#### **Addendum 84 – Regulation No. 85**

#### **Revision 1 - Amendment 1**

#### **Uniform provisions concerning the approval of internal combustion engines or electric drive trains intended for the propulsion of motor vehicles of categories M and N with regard to the measurement of the net power and the maximum 30 minutes power of electric drive trains**

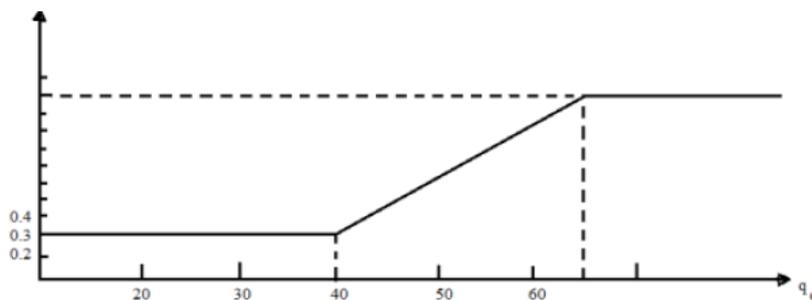
Paragraphs 5.4. to 5.4.3. (adding a new paragraph 5.4.3.), amend to read:

$f_m$  is a function of  $q_c$  (fuel flow corrected) as follows:

This formula is valid for a value interval of  $q_c$  included between 40 mg/(l.cycle) and 65 mg/(l.cycle.)

For  $q_c$  values lower than 40 mg/(l.cycle), a constant value of  $f_m$  equal to 0.3 ( $f_m = 0.3$ ) will be taken.

For  $q_c$  values higher than 65 mg/(l.cycle), a constant value of  $f_m$  equal to 1.2 ( $f_m = 1.2$ ) will be taken (see figure):

$$f_m = 0.036 q_c - 1.14$$
